Remarks on the FDR design of the FOS vacuum diagnostic chamber FPF2DK1:

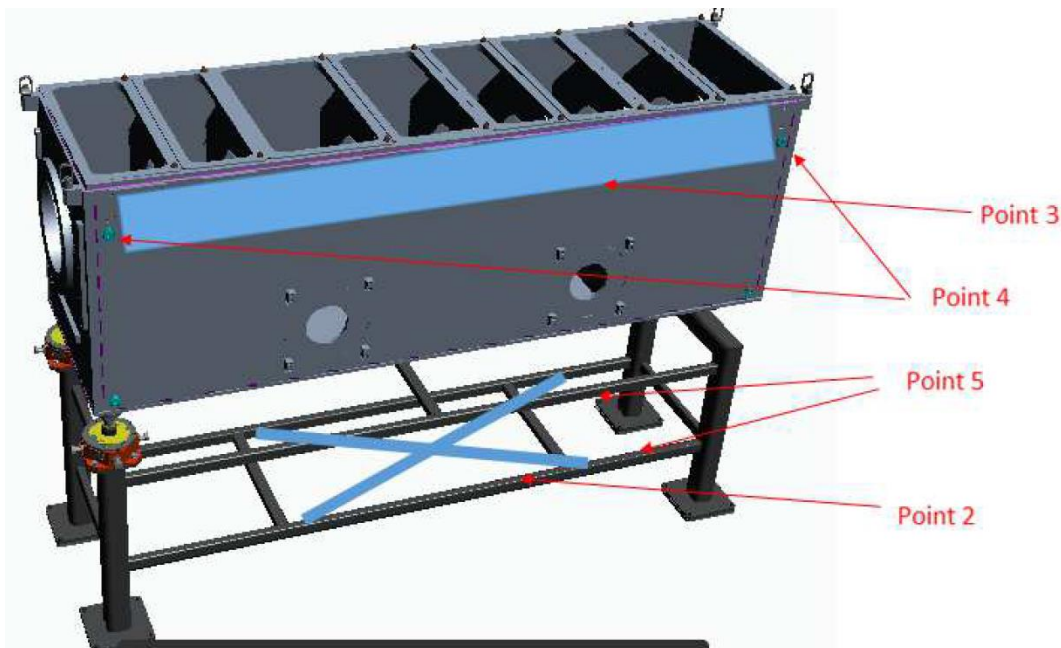
- 1) When assembling the vacuum chamber, information for the leak rate and cleaning is missing.
- 2) For the individual parts of the vacuum chamber, the material specification is only "Stainless Steel". This should be specified in more detail.
- 3) In some cases, machined surfaces which are not sealing surfaces were indicated with a surface roughness of Rz 6.3 microns. Please specify Rz 25 microns for such areas.
- 4) In the case of a flange, the position tolerance of the threaded holes is missing.
- 5) The base frame looks somewhat fragile compared to the vacuum chamber.
- 6) The horizontal struts of the frame have only a general tolerance. With the longest strut of 3080mm, a difference in length of 4mm is expected in the worst case.

1). The alignment feet of the chamber are placed at the corners or at the edge of the chamber. This could allow a larger bending of the chamber. Are there any calculations of the chamber bending /strength by fully equipped chamber (8 drives x750kg each) under vacuum? What is the max bending of it?

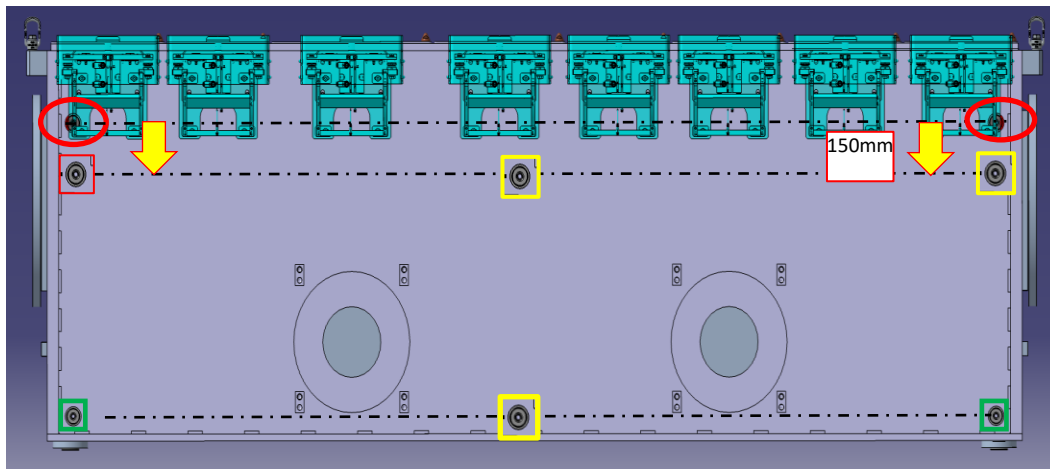
2). The struts of the chamber stand are not cross reinforced. Are there any strength calculations?
